RE: Wagner Rock Pit, Permit/File No. M-1999-018, Objection Response Forwarded

Wagner Rock Pit #M-1999-018c Conversion.
Application Objections Response

EXHIBIT "A" WAGNER PIT

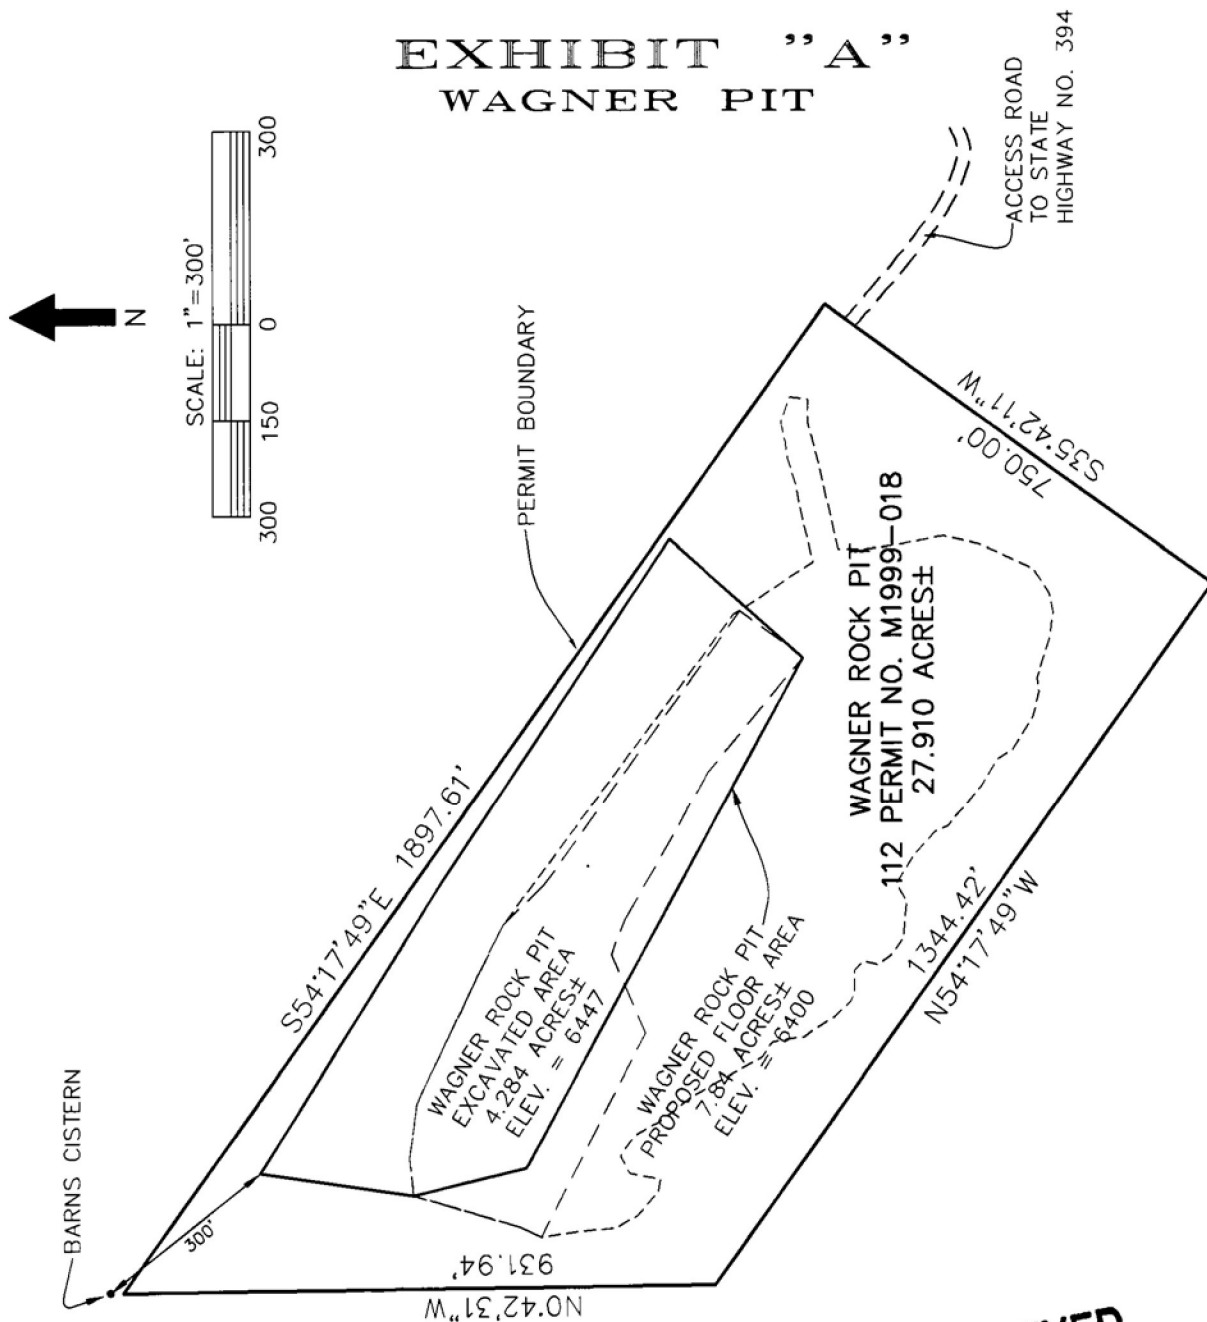
Mining activity affecting Murphy Spring

Sediment from Surface Water affecting the Murphy Spring

The Murphy Spring is 1200 feet from the West boundary and is located in a ravine. Surface water from the permit would have to travel 1200' to affect this spring. The ravine is heavily vegetated. There is currently a sediment pond located on the South side of the pit that collects run-off from the alfalfa fields south of the pit. The pit is on top of a ridge that self contains all storm water on site. The pit currently has ditching and catch basins in use to prevent any sediment or excessive erosion. No storm water flows or sediment from Wagner Rock Pit have ever affected the Murphy Spring or exited to disturbed area. Existing erosion control features will remain in place and maintained annually.

Attached is a drawing that illustrates the current disturbed area, the proposed finished floor elevation in relation to the North permit boundary, Murphy Spring and Barns Cistern.

Closest disturbance from the proposed pit floor to the Barns Cistern will be 300' and 1200' from the Murphy Spring.
